**ALERT SERVICE BULLETIN**

NO. 222U-00-57

**MODEL AFFECTED:** Model 222U

**SUBJECT:** HYDRAULIC ACTUATOR SUPPORT P/N 222-040-125-001, INSPECTION OF

**Hydraulic Actuator  
Support Assembly  
P/N 222-040-125-001  
Figure 1**

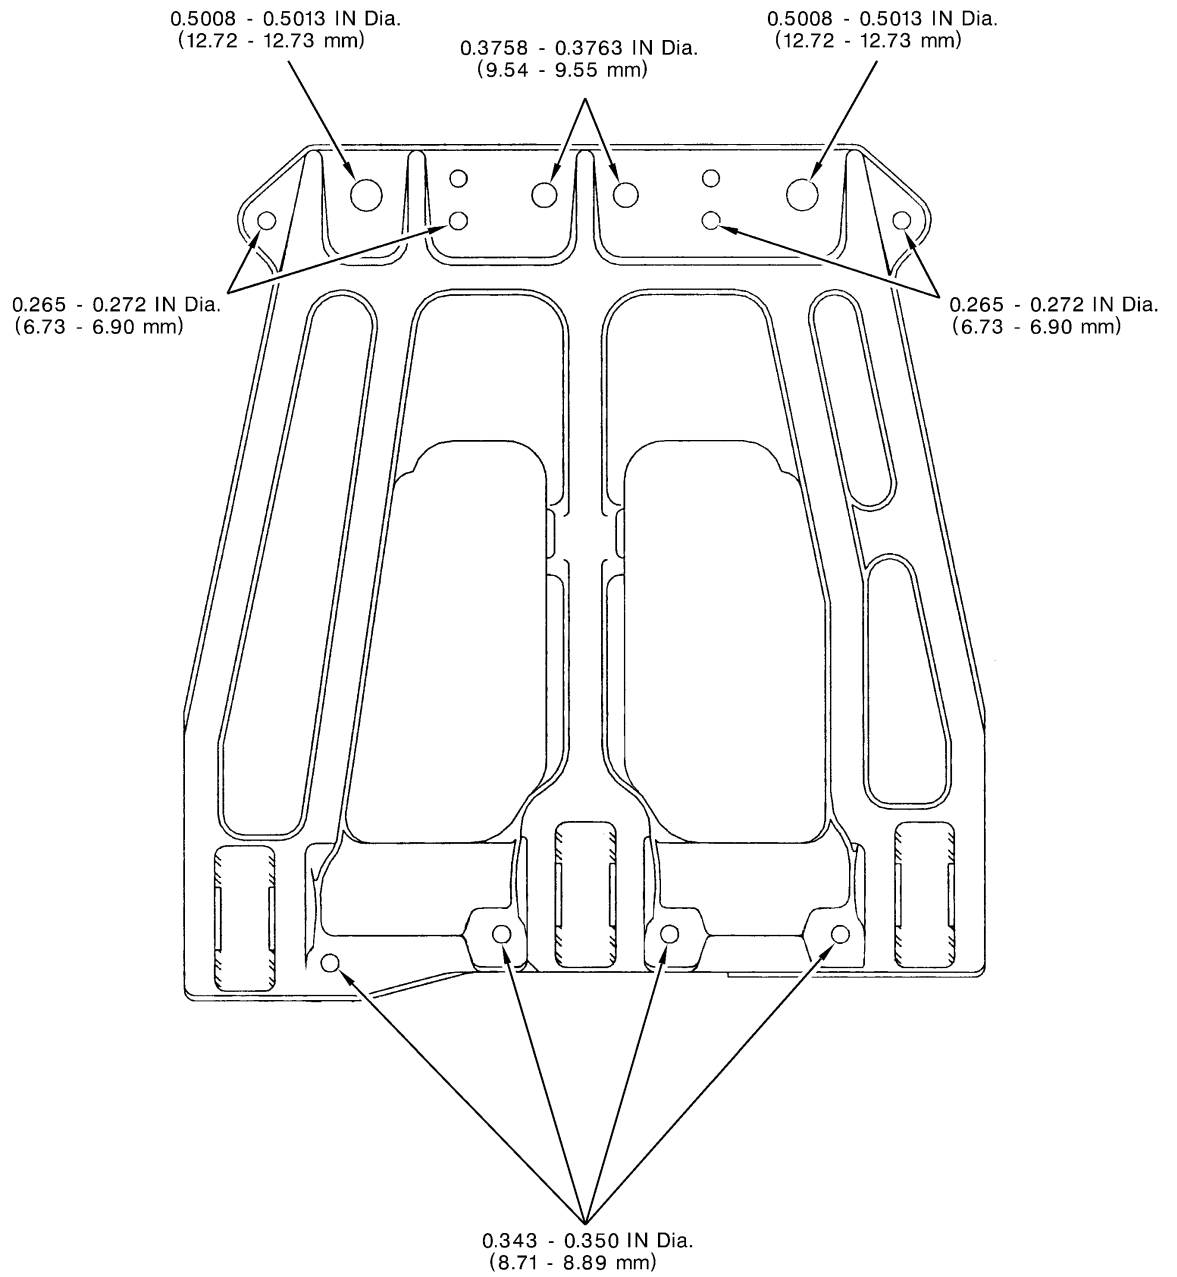
4. If two or more of the nuts within the upper row of the support attaching nuts move below 40 in.lb torque or two or more of the nuts within the lower row of the support attaching nuts move below 90 in.lb torque, remove the hydraulic actuators support from the transmission for further inspection and repair. Refer to BHT-222U-MM-6, Chapter 63 and BHT-222-CR&O-2, Chapter 63 for removal instructions. Discard nuts and washers.
5. If required, inspect the support P/N 222-040-125-001 in accordance with instructions in BHT-222-CR&O-2, Chapter 63. The holes at the lower and upper end of the support were manufactured to the dimensions shown in figure 1.

**Transmission Top Case Assembly**  
**P/N 222-040-061-101 through 105**  
**Figure 2**

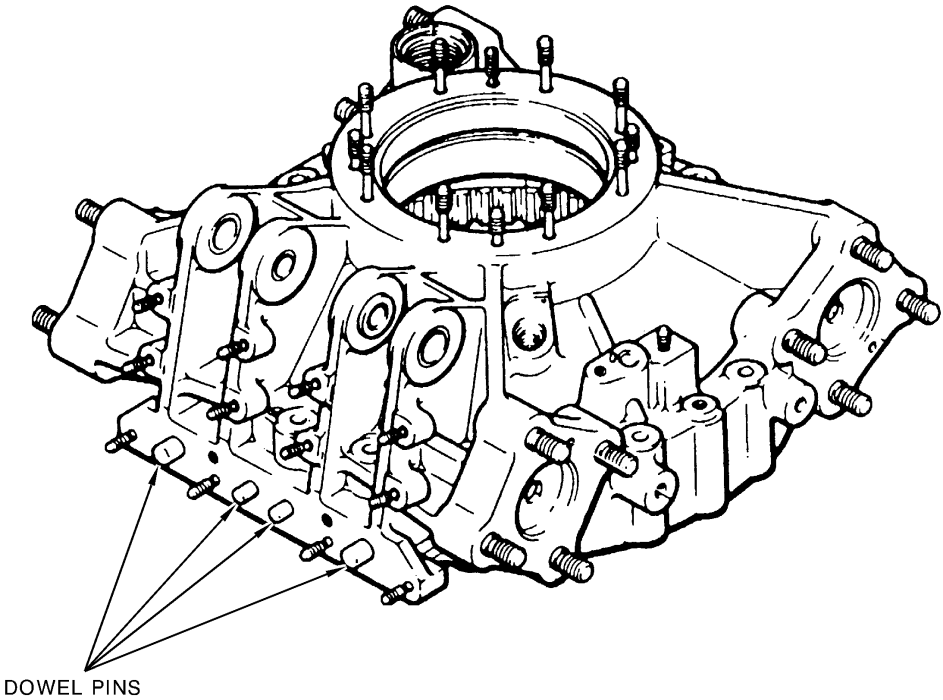
7. If required, inspect the transmission upper case assembly as follows:
  - a) Inspect surface of transmission case in contact with the actuator support for damage, fretting and corrosion. Maximum depth and/or size of corrosion, wear, scratches, nicks and marks shall not exceed 0.005 inch depth, 40% of any one square inch or more than 20% of the total surface. Pitting/corrosion around studs and dowel pins shall not exceed 0.005 depth or 50% of the circumference of the stud/dowel pin.

- c) Inspect the dowel pins in transmission case for damage, fretting , corrosion and looseness. The large outboard pins should measure 0.500 inch minimum and protrude 0.55 inch from the surface of the case. The small inboard pins should measure 0.375 inch minimum and protrude 0.45 inch from the surface of the case. Refer to Figure 2
